Interactive comment on “Pump schedules optimisation with pressure aspects in complex large-scale water distribution systems” by P. Skworcow et al.

Received and published: 22 April 2014

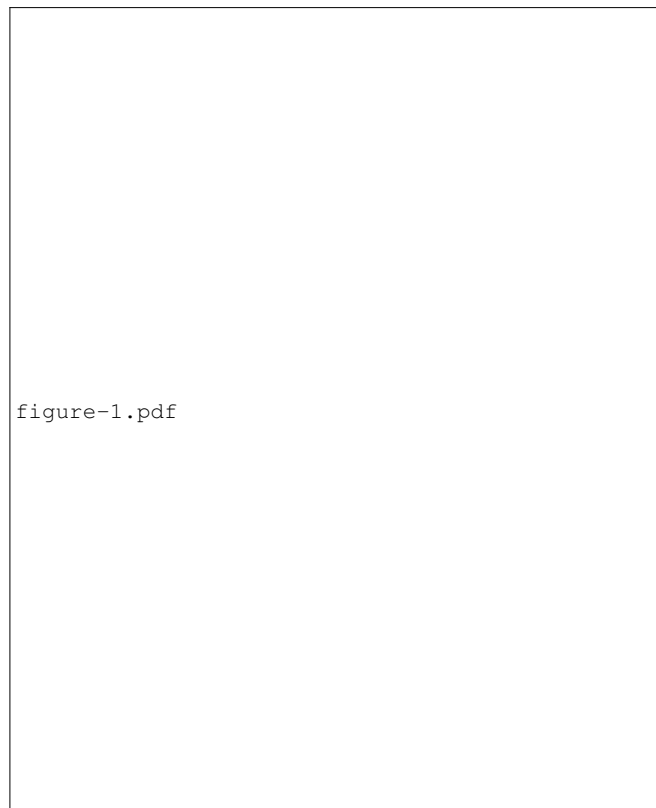
- *It would have been very helpful to have provided a schematic map of the distribution.*

A schematic of the network with fictitious names will be provided to the editor to be included in the final version of the paper. The schematic is also attached to this reply.
